# UNITED STATES PATENT AND TRADEMARK OFFICE

APPLICATION NO.	FILING DATE	FIRST NAMED INVENTOR	ATTORNEY DOCKET NO.	CONFIRMATION NO.
10/689,976	10/21/2003	Glenn A. Rinne	9180-24	3798

<b>Office Action Summary</b>	<b>Application No.</b> 10/689,976	<b>Applicant(s)</b> RINNE, GLENN ET AL.	
	<b>Examiner</b> Jennifer Matisiak	<b>Art Unit</b> 2811

**DETAILED ACTION**

Fig. 1

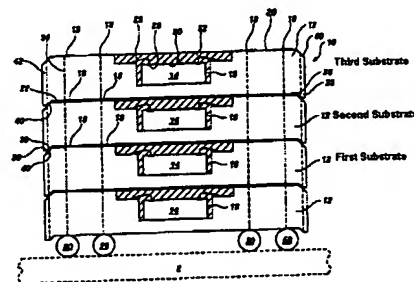
Regarding claim 42, Moden discloses an electronic device (Fig. 1 as shown below, for example) comprising: a first electronic substrate (Fig. 1 as shown below) having opposing first and second

surfaces; a second electronic substrate on the first electronic substrate, the second electronic substrate having opposing first and second surfaces; a third electronic substrate, on the second electronic substrate, the third electronic

substrate having opposing first and second surfaces, wherein the second electronic substrate is between the first and third electronic substrates; and a signal path (24 of

Fig. 2, for example) extending along the first surface of the second electronic substrate (Fig. 1), to the second surface of the first electronic substrate (Fig. 1), along the second surface of the first electronic substrate (24 of Fig. 2 through 14 of Fig. 1), to the first surface of the third electronic substrate (Fig. 1), along the first surface of the third electronic substrate (24 of Fig. 2 through 14 of Fig. 1), and to the second surface of the second electronic substrate.

Regarding claim 43, Moden discloses an electronic device (Figs. 1 and 2) wherein the signal path comprises a first conductive trace (24 of Fig. 2 as aforementioned above) on the first surface of the second electronic substrate (as aforementioned above), a first electrical and mechanical connection between the first surface of the second electronic substrate and the second surface of the first electronic substrate (18 of Fig. 1), a second conductive trace (24 of Fig. 2 as aforementioned above) on the second surface of the first electronic substrate, a second electrical and mechanical connection between the second surface of the first electronic substrate and the first surface of the third electronic substrate (18 of Fig. 1), a third conductive trace of the first surface of the third electronic substrate (24 of Fig. 2 as aforementioned above), and a third electrical and mechanical connection between the first surface of the third electronic substrate and the second surface of the second electronic substrate (18 of Fig. 1).

Fig. 4

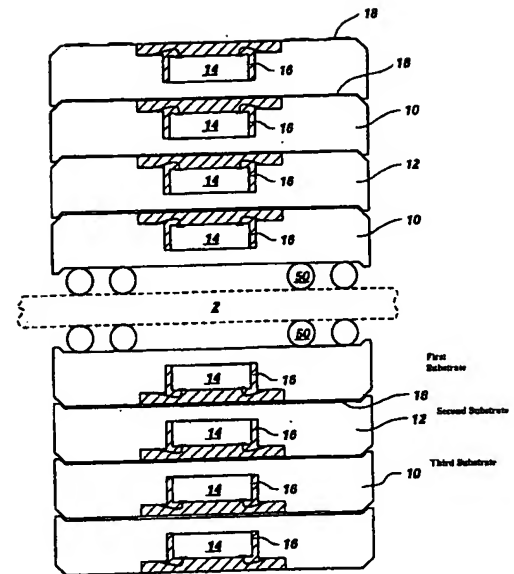
Regarding claim 45, Moden discloses an electronic device (device below substrate 2 of Fig. 4) wherein the first and third electronic substrates comprise integrated circuit devices (14 of Fig. 4), wherein the first side of the first

(10 of Fig. 4) and third (10 of Fig. 4)

electronic substrates comprises a device side and wherein the second side of the first and third electronic substrates comprises a backside.

Regarding claim 46, Moden discloses an electronic device (Fig. 4) wherein the signal path is electrically coupled (18 of Fig. 4) to an electronic circuit of the third electronic substrate.

Regarding claim 47, Moden discloses an electronic device (Fig. 4) wherein the second electronic substrate comprises an integrated circuit device, wherein the first side of the second electronic substrate comprises a device side and wherein the second side of the second electronic substrate comprises a backside (14 of Fig. 4).

Regarding claim 48, Moden discloses an electronic device (Fig. 4) wherein the signal path is electrically coupled to an electronic circuit of the second electronic substrate and to an electronic circuit of the third electronic substrate (18 of Fig. 4).
